# SAN FRANCISCO PLANNING DEPARTMENT

## Discretionary Review Full Analysis

*Date:* June 9, 2016  
*Case No.:* 2015-003610DRP  
*Project Address:* 2181 9<sup>th</sup> Avenue  
*Permit Application:* 2015.03.19.1328  
*Zoning:* RH-1(D) (Residential House, One-Family-Detached)  
40-X Height and Bulk District  
*Block/Lot:* 2860/004  
*Project Sponsor:* Alexander Lirisman  
Forum Design  
1014 Howard Street  
San Francisco, CA 94103  
*Staff Contact:* Nancy Tran – (415) 575-9174  
[nancy.h.tran@sfgov.org](mailto:nancy.h.tran@sfgov.org)  
*Recommendation:* **Do not take DR and approve the project as proposed**

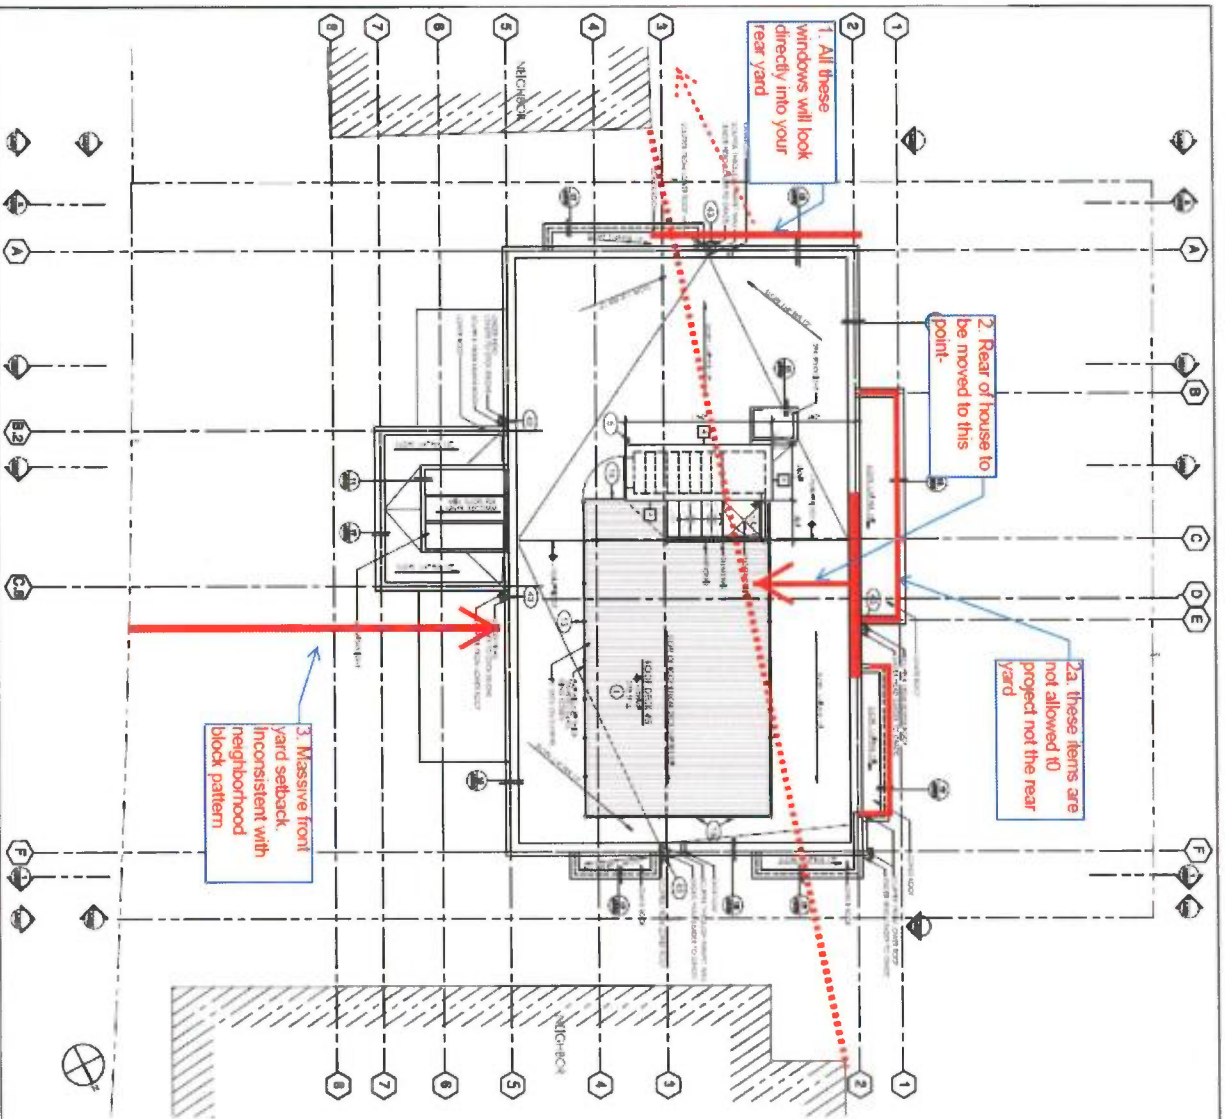
Section III of the Residential Design Guidelines states that the front setback should be treated so that it provides a pedestrian scale and enhances the street. The proposed project is pushed far back on the property to what we can tell to be 23' from the property line at the entry level. Drawing A001 (site plan) is misleading as it uses mostly sub-grade space (garage / media room) as well as entry deck to establish the front plane of the house. In reality, Grid line 6 marks the front face of the house which is set back 8' from the front of 2193 9th Avenue. All other houses on the block share a relatively consistent 15' setback. [See Exhibits 2A and 2B which redlines A001 and illustrates the true sitting of the house]

- 1) **Lighting:** As the proposed project exceeds the depth of our house by 17' (and is also 4' deeper than the house to its left which the developer also owns), the new house will block light into our kitchen on the first floor, and bedroom on the second floor, and most importantly, any light that we get on the only flat section of our backyard.
  - 2) **Privacy:** The proposed house is pushed very far back from the street such that the side yard windows will look directly into the interior of our house (kitchen on the first floor, and bedroom on the second floor), and also in to our yard. [See Exhibits 3 and 4A]
- 3. What alternatives or changes to the proposed project, beyond the changes (if any) already made would respond to the exceptional and extraordinary circumstances and reduce the adverse effects noted above in question #1?**

As suggested in Section IV of the Residential Design Guidelines, we recommend reduction of the footprint of the proposed building to adhere to mid-block open space pattern. [See Exhibit 5] The proposed project should match the average of the front and rear setback of the two adjacent homes. Once the scale of the house is reduced to be compatible with its surroundings, care should be taken to develop window configurations that break the line of sight between houses, and employ the use of translucent glazing such as glass block or frosted glass on windows and doors facing openings on abutting structures.

PROPOSED SOUTH ELEVATION REVISION - SEP. 16, 2014

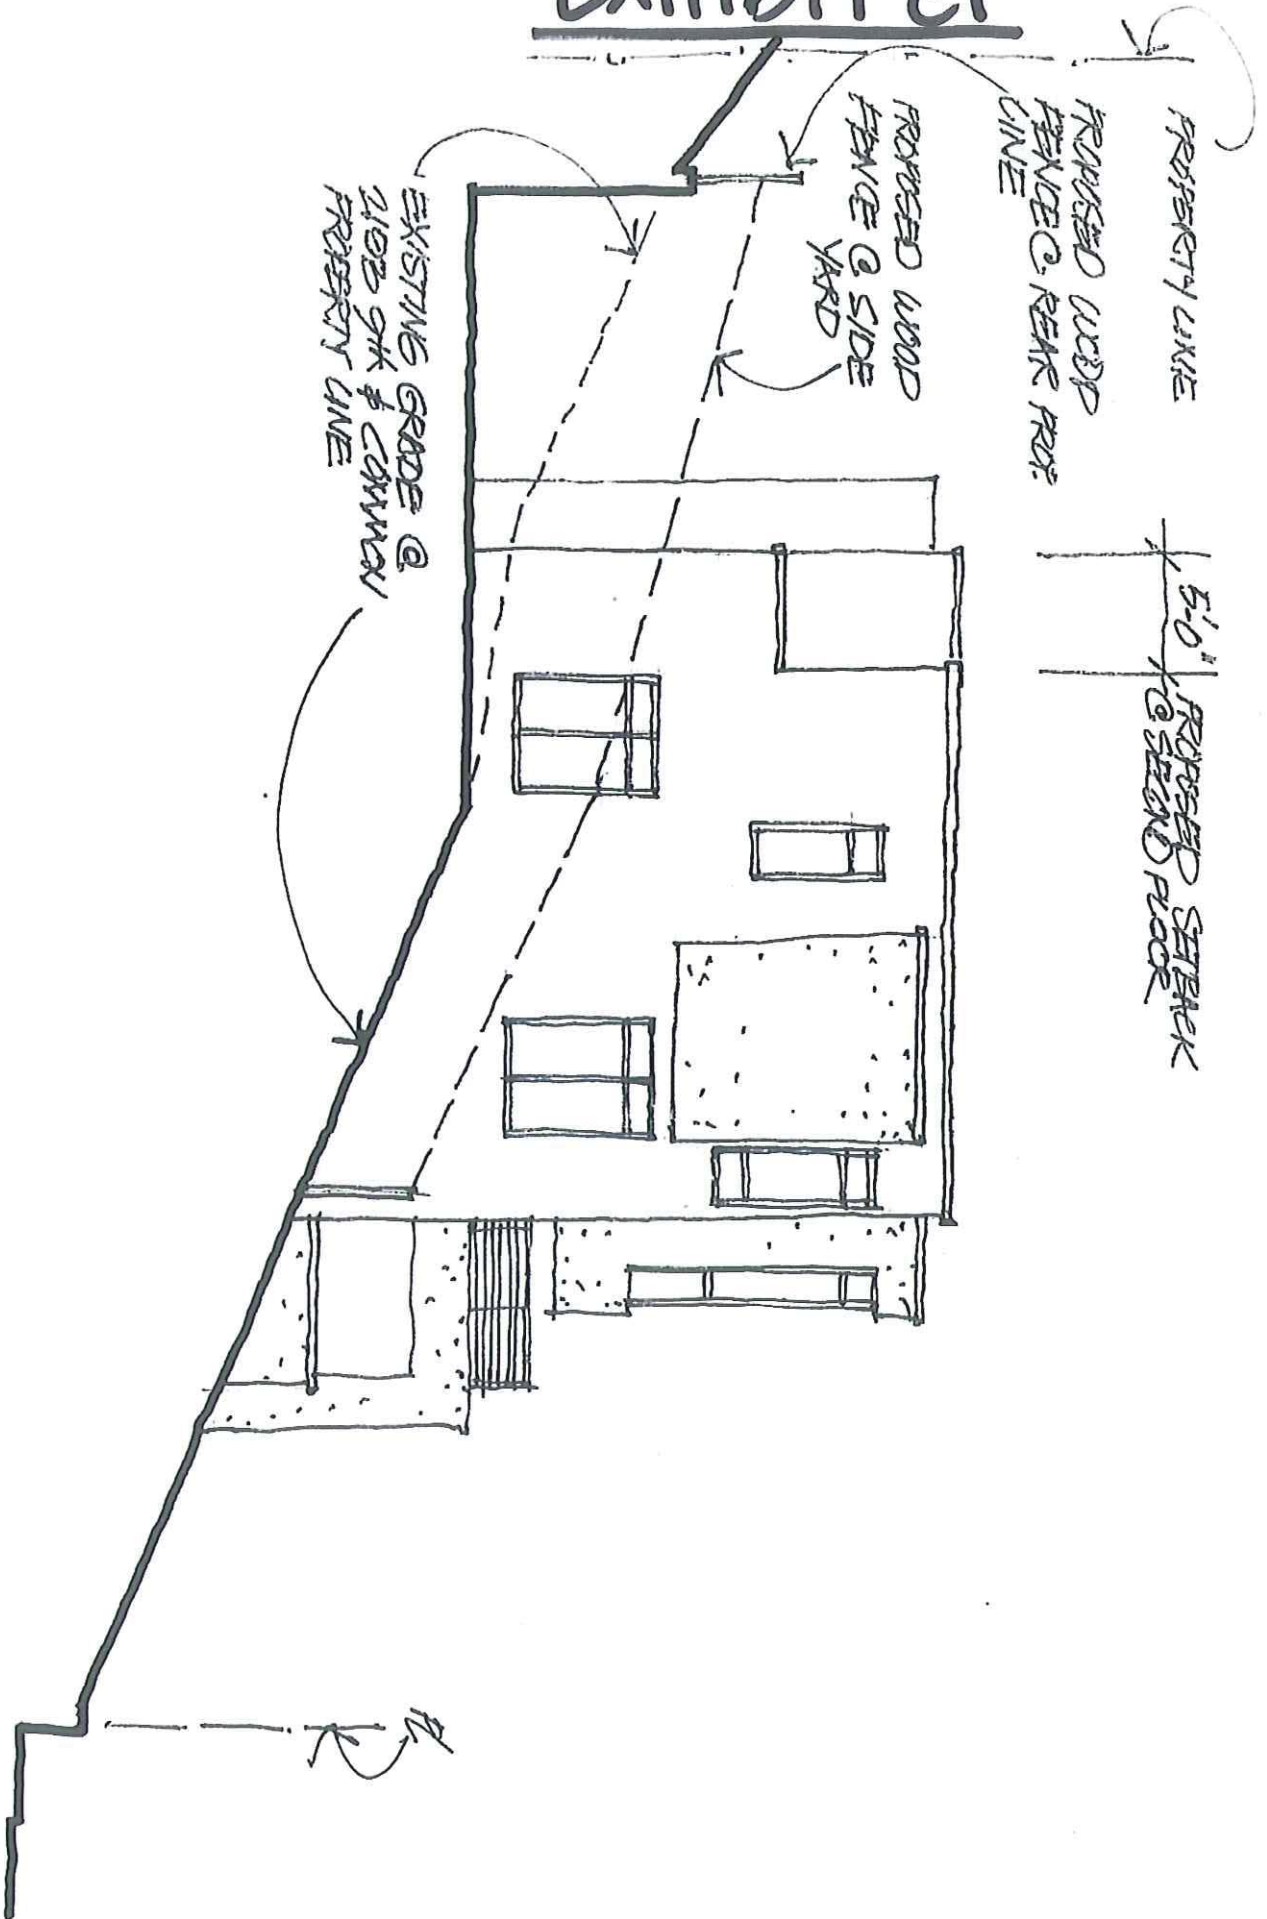
Please see enclosed the sketch dated September 16<sup>th</sup>, 2014 (and presented to you October 9<sup>th</sup>, 2014) with the proposed 5' shift forward of the bedrooms adjacent to your home.
